Accredited Standards Committee
X3, Information Processing Systems

Doc: X3T10.1/96a172r2
Date: November 13, 1996
Project: X3T10.1 / 1147D & 1051D
Ref Doc.: SSA-TL2 rev 3
Reply to: Adge Hawes

Subject: Simplification of Extended Distance Option

Figure 1. Comparison of normal and EDO protocols

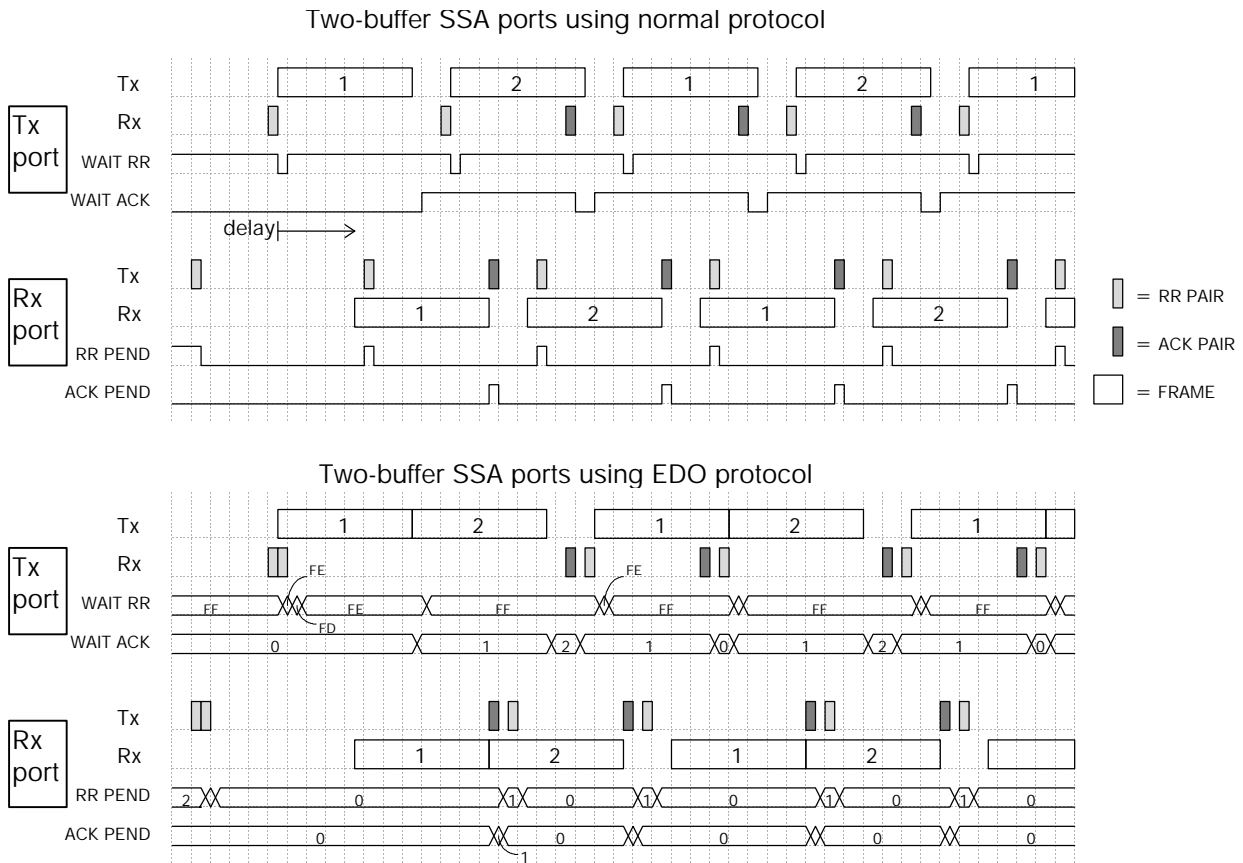
It should be noted that a port that implements the EDO rules may enjoy performance benefits over longer distances even if it implements only two buffers. This is because the two buffers can send out both their RR-pairs earlier than a non-EDO port; the latter requires reception of the control field of a frame before it can send out the second RR pair. This 'head start' means that the second frame may be sent earlier. Also, the second frame may be completely transmitted (without holding off the trailing FLAG) while the first ACK is outstanding, allowing the receiver to process the incoming frame sooner. This is illustrated in Figure 1, which shows how the traffic flows on a long SSA link (where the propagation delay is of similar size to the frame time) with each type of protocol.

Therefore, if the cost of the counters for the flags is acceptable, EDO capability may be the preferred design method for ports with even modest buffering.

Figure 11 - Timing of acknowledgments (non extended distance operation)

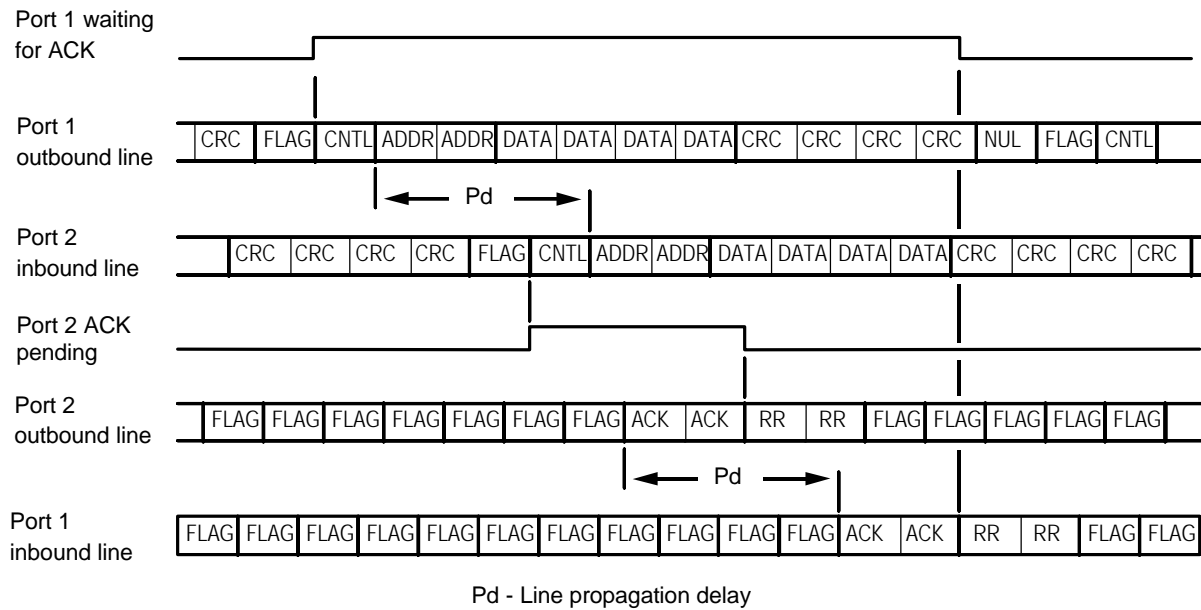
The timing requirements for acknowledgments and the use of NUL characters for non-Extended Distance operation is illustrated in Figure 11, where port 1 and port 2 are on opposite ends of a link (i.e., on different nodes). Port 1 finishes sending a first frame and then it immediately sends a second short frame. Due to the delay before port 2 acknowledges the first frame port 1 has to insert a NUL character in the second frame.
